Addendum #05 for RFB #951800-01

Project Name: DOM-IT Jessie Parker South Renovation

Date: May 01, 2026

Addendum #05:

E230

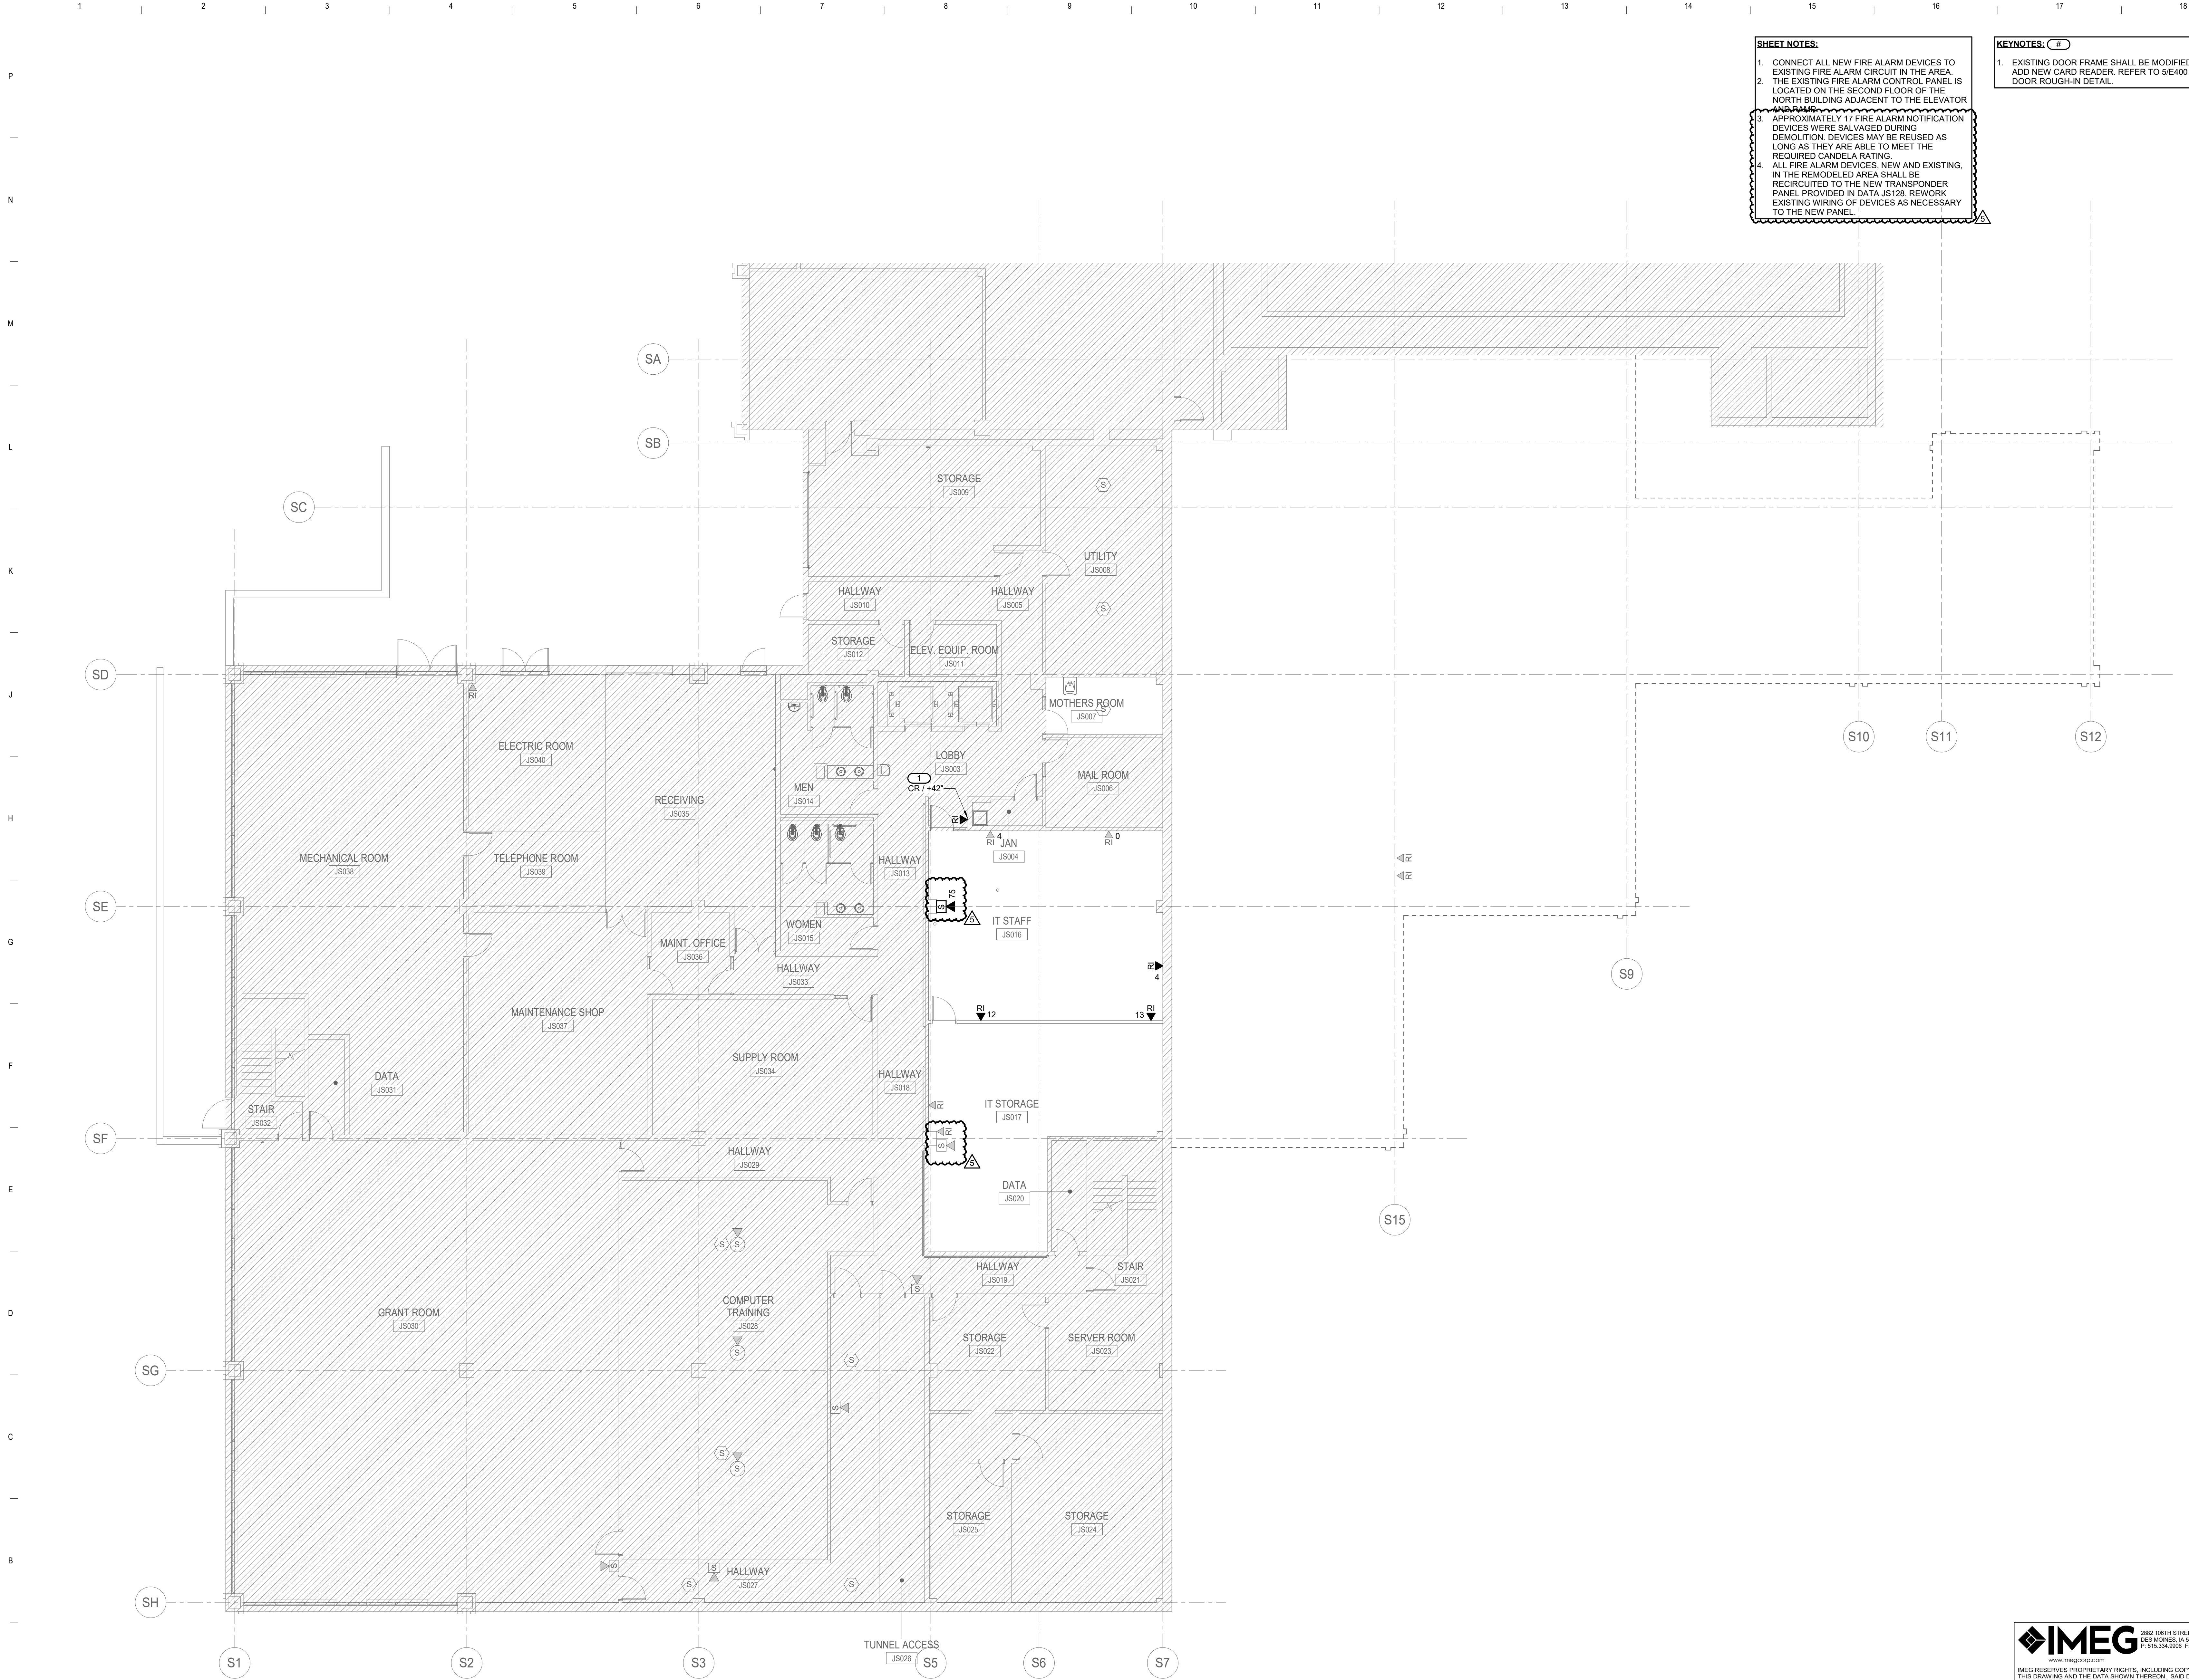
1. Drawing E000 – ELECTRICAL COVERSHEET:
 - a. REVISE fire alarm horn symbol to a speaker symbol.
2. Drawing E230 – LOWER LEVEL FLOOR PLAN - SYSTEMS:
 - a. ADD sheet notes #3 and #4.
 - b. REVISE fire alarm horn notification devices to speaker type.
3. Drawing E231 – LEVEL 1 FLOOR PLAN - SYSTEMS:
 - a. ADD sheet notes #5 & #6.
 - b. ADD keynote #5.
 - c. ADD new fire alarm transponder panel in Data JS128.
 - d. REVISE fire alarm horn notification devices to speaker type.
4. Drawing E232 – LEVEL 2 FLOOR PLAN - SYSTEMS:
 - a. ADD sheet note #5 and #6.
 - b. REVISE fire alarm horn notification devices to speaker type.
5. Drawing E400 – ELECTRICAL DETAILS:
 - a. REVISE details #2 and #4.
